**Final Acceptance (FA) Punchlist**  
**EPC - DPW - Stormwater Section**

Project Name:	14160 Stone Eagle Place
EDARP Filing Number(s):	CDR2119
ESQCP Number:	ESQ226
Attendees:	DPW SW: Ben Jones, Molly Layshock DPW Planning: N/A Builder: Jorge Escarcega
Date of Walk-Thru:	2/27/2023
Walk-Thru Number:	1 <sup>st</sup> FA Walk

Photo 1: Finish landscaping/final stabilizing at bare areas at rear of lot. It is recommended to leave straw wattles in place until adequate vegetation is present.

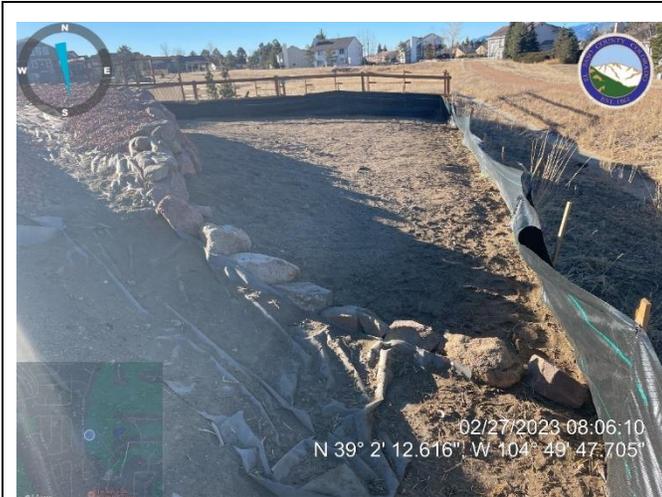
Photo 2: Finish landscaping/final stabilizing at bare areas at rear of lot. It is recommended to leave straw wattles in place until adequate vegetation is present.

Photo 3: Add more staples as per manufacturers recommendation to ECB adjacent to 14172 Stone Eagle
